North Hertfordshire District Council
Building Conservation comments

File Ref: 18/01111/LBC
Date: 24/09/2018
Planning Officer: SD
Address: Fats 8A, 8B and 8C Upper King Street, Royston SG8 9AZ
Subject: Internal alterations to three existing first and second floor residential units to create 2 x two bedroom and 2 x one bedroom flats.

Alternative Second floor Layout.

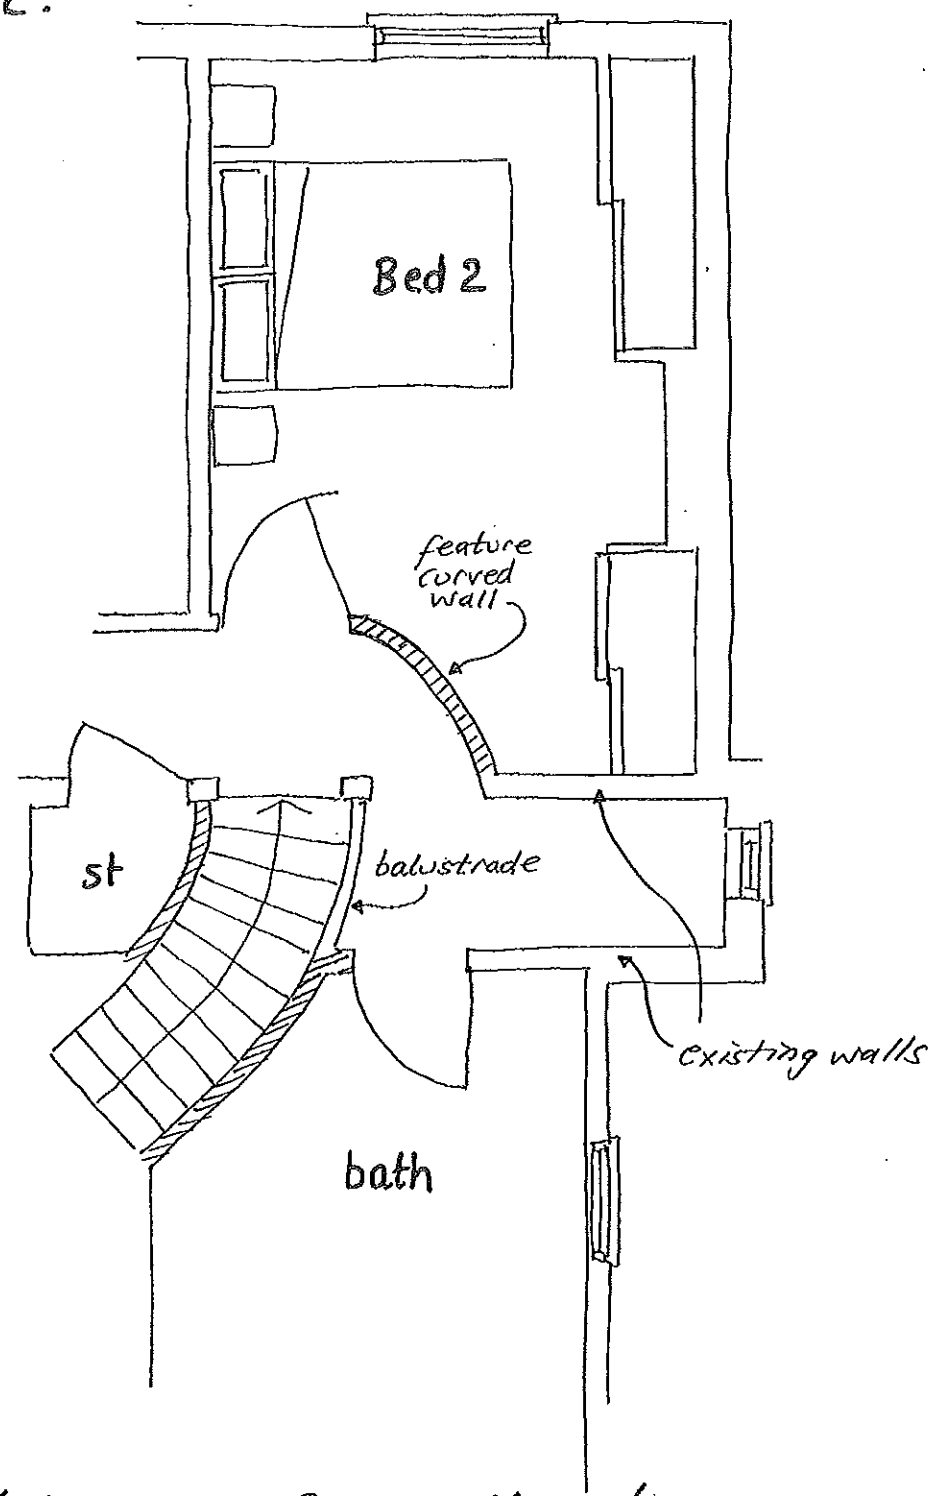
Unit 4
This unit requires a similar amount of intervention to the first floor as that required to form Unit 2. In addition, however, sections of lath-and-plaster walls at second floor would also need to be removed to facilitate the reconfigured interior at the top of the new stairs including the creation of the bathroom. Although headroom is relatively low and may require the ceiling to be raised, there is a case to suggest that the bathroom could be relocated into the 'attic' space which would leave part of the existing kitchen stud wall intact both enlarging Bedroom 2 and perhaps providing an alcove for a wardrobe(s). There would be a residual area i.e. where the bath is currently shown, which would then nether be in Bed 2 or in the bathroom, however, if the top part of the staircase had a balustrade then the small window on the side elevation could provide natural light at the top of the stairs. Justification is required as to why the attic space cannot be used for this purpose. I also question as to whether it would be better to locate the kitchen to Unit 4 onto the wall dividing this room from Bed 1 to perhaps improve the entrance into the main living space i.e. kitchen units located behind the door. There is a case to suggest that the new staircase could, in fact, make a positive contribution to Flat 4. The fact that the second floor was added in the late C19, I attach moderate significance to this additional floor and the staircase which provides access to this floor.

However, subject to receiving feedback regarding suggested changes, I may be minded to conclude that the alterations would not occasion sufficient harm to elements of the building's special character to justify a refusal but in order to satisfy the provisions of Section 16 of the Planning (Listed Buildings and Conservation Areas) Act 1990 and Section 16 of the NPPF further work is necessary in terms of justification and alterations proposed.

for discussion purposes.
M. Simmons
24 Sept 2018.
